Docket Item # 9
BAR CASE #2008-0243

BAR Meeting
January 7, 2009

ISSUE: Signage & Alterations

LOCATION: 610 Montgomery St

Figure 1 Front & Rear Elevations & Roof Layout

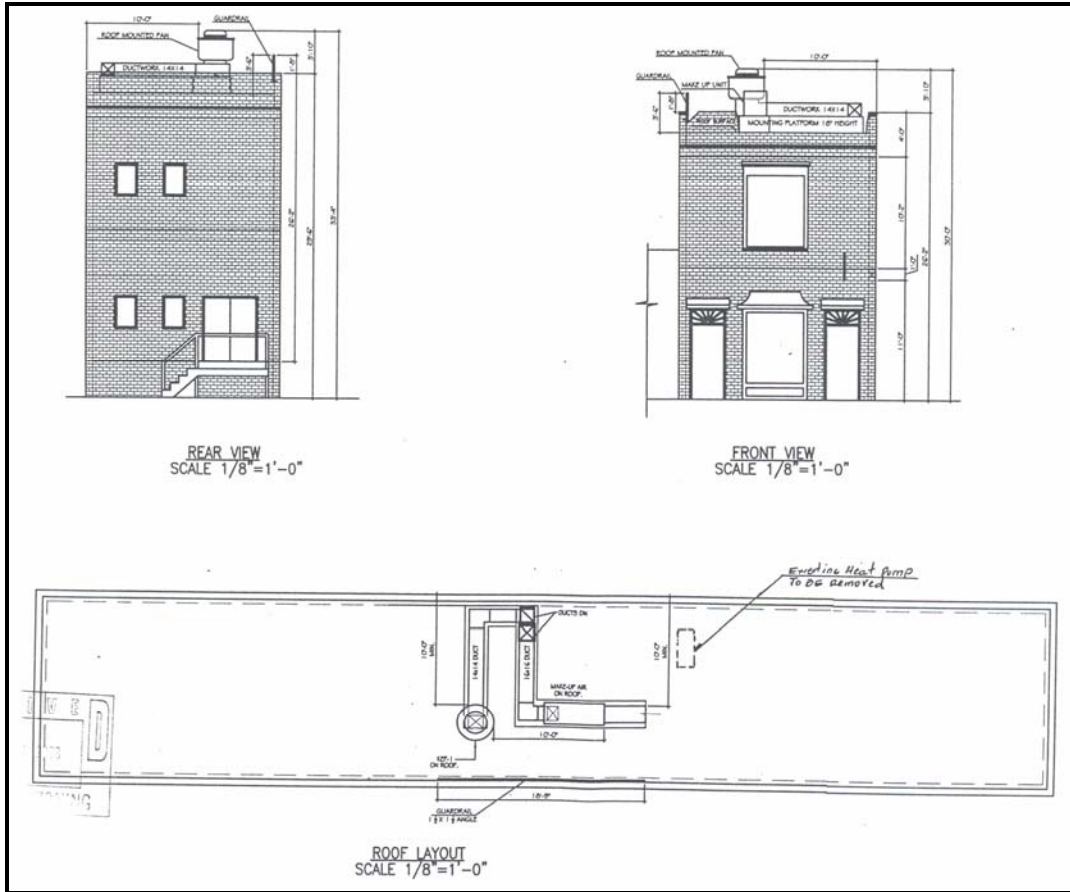
As stated in the Design Guidelines, “Exhaust and supply fans are an important functional element of many commercial properties and are particularly important for restaurants,” which is why Staff believes that although the proposed unit will be visible from both Montgomery Street and Washington Street, the installation is a needed alteration. Furthermore the applicant has taken measures to insure that the unit has been positioned on the roof so as to be as unobtrusive to the building as possible. The proposed guardrail is a mandatory alteration as set forth by the USBC for all exhaust fans located closer than 10’ from the edge of a roof of a commercial structure.

- C-4 Structural calculations are required to verify the ability of the existing roof to support the additional weight of the rooftop unit.
- C-5 Guardrail structural design and construction must comply with USBC.

- C-6 Where appliances are located $\leq 10'$ from a roof edge or open side with a drop $\geq 24"$, guards shall be provided (USBC 2801.1)
- C-7 Alterations to the existing structure must comply with the current edition of the Uniform Statewide Building Code (USBC).

IV. STAFF RECOMMENDATION: Staff recommends approval of the application with the condition that both the exhaust unit and guardrail be painted the predominant color of the roof.
